Having considered the Anderson Acoustics technical memo Ref: 7129_001M_5-0_DM I remain concerned about the impact of noise from the nighttime economy on the future occupiers of the proposed development.

Figure 1 – Façade directly onlooking the Newbury Terrace

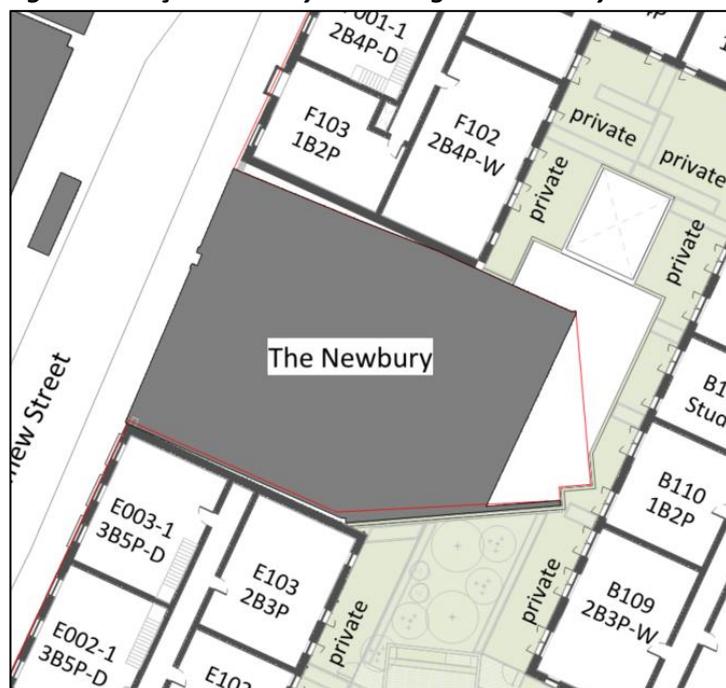
The flats in block B are in extreme close proximity to the terrace and would directly overlook it. Flats in blocks E and F would also be significantly affected. It appears that there are around 100 flats with exposed facades.

Yes, this is true, however the facades of blocks E and F that directly overlook the terrace do not have any glazed elements (which are considered the weakest elements of a façade with regard to noise, see a GA plan for the 1st floor below, this is the case for all floors on these facades). Only Block B facades directly overlook the Newbury – even though these are set further away, the potential impact is significant and our recommendations are to introduce winter gardens in order to adequately protect the residential amenity in the habitable rooms exposed.
